গণপ্রজাতন্ত্রী বাংলাদেশ সরকার  
শ্রম ও কর্মসংস্থান মন্ত্রণালয়  
কলকারখানা ও প্রতিষ্ঠান পরিদর্শন অধিদপ্তর

ক্যাপ পর্যবেক্ষণের তথ্য

কারখানার নাম	কতুল্লা, এয়াপারেলস		
ঠিকানা	B-68/1 Wapda Road, Jalkuri, Siddirganj, Narayanganj		
কারখানার কোড	NRY087		
কালার কোড			
মূল্যায়নের ধরণ: <a href="#">কঠামোগত মূল্যায়ন</a>		পর্যবেক্ষণের তারিখ: ০১-০২-২০২৩	
১. পর্যবেক্ষণ

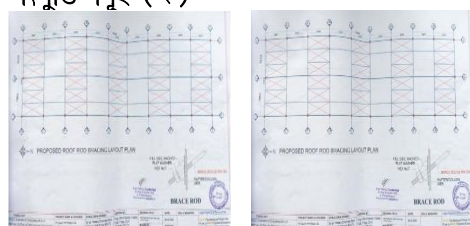
কার্যক্রম	Install vertical bracing if required.
সুপারিশের তথ্যসূত্র	
কারখানার কার্যক্রম	We shall Install vertical bracing after getting the stability report if it requires
অগ্রাধিকার	
চূড়ান্ত সময়সীমা	১৫-০৯-২০১৬
সংশোধিত সময়সীমা	০১-০১-১৯৭০
অগ্রগতির অবস্থা	চলমান
মন্তব্য	28-Aug-2022: After Submission of DEA report DIFE have some correction. Factory management says that, they has been start to work this correction & Corrected DEA report will submit to DIFE as soon as possible. Proposed Bracing layout plan & sectional drawing found on site. 01.Feb.2023: After Submission of DEA report DIFE have some correction. Factory management says that, they has been start to work this correction & Corrected DEA report will submit to DIFE as soon as possible.
